## **Circuit Change**

# Technical Bulletin L70

**Hardware Technical Bulletin:** L70-H2004-05

**Subject:** Fan Kit Installation

*Photo 1*

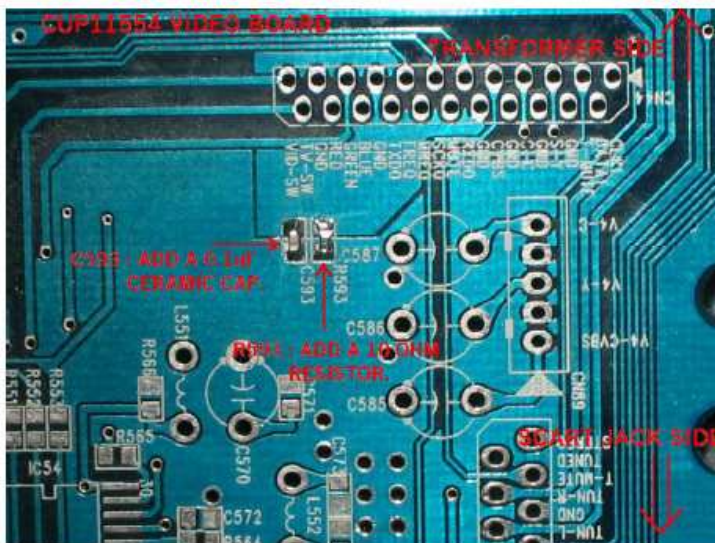
**PROBLEM:** *When using the component out on the L70 you may find the video signal has faint diagonal lines appearing.*

**CAUSE:** *The ground plane requires additional coupling.*

**SOLUTION:** *Add a 10 ohm resistor to location R593 on the video board. Add a 0.1uF ceramic capacitor to location C593 on the video board. See photo below.*

**Photo**

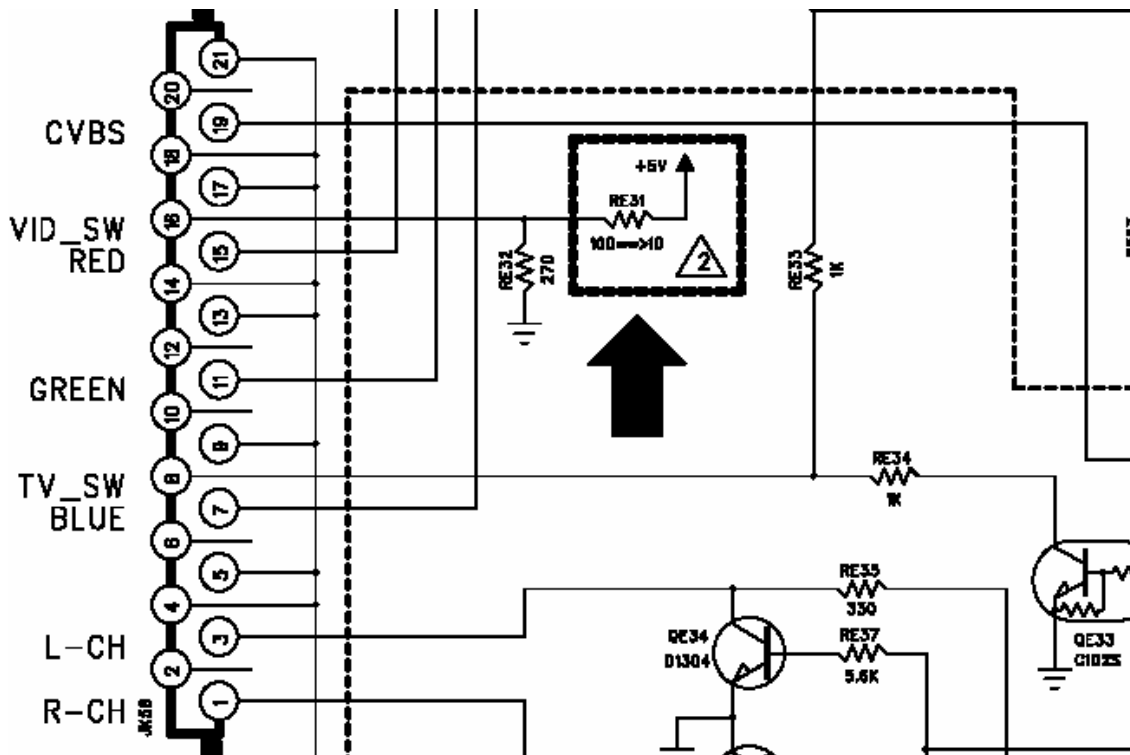
**PROBLEM:** You may have the complaint that the TV SCART RGB output is not switching automatically.

**CAUSE:** The drive current of some television sets is not sufficient to switch the RGB output.

Delete RE31 100 ohm resistor on video board.

Add a 10 ohm resistor between PIN 16 of SCART connector (one leg of RE31) and +5V rail(one leg of R554) on video board. See photo and schematic diagram.

Figure 1

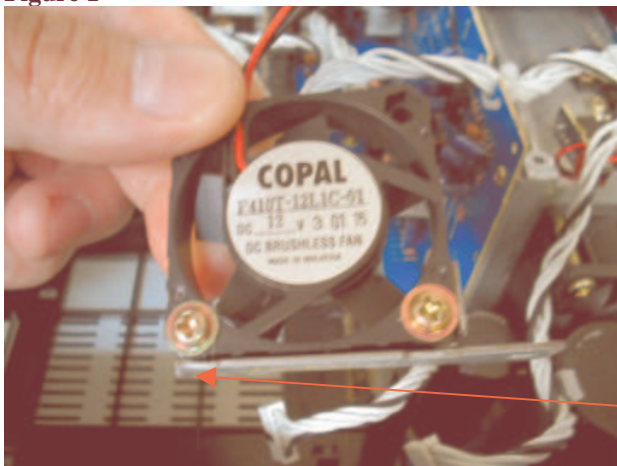
**DESCRIPTION:** The small ventilation fan located on the DVD mechanism, is noisy or is turning too slowly.

**REASON:** The fan bearing is worn.

1. As shown cut the supplied bracket in order to install it with the new fan.
2. Secure fan to the bracket and add some glue to the bottom of the bracket when securing to the chassis. See figure 1 and 2.

Cut bracket here
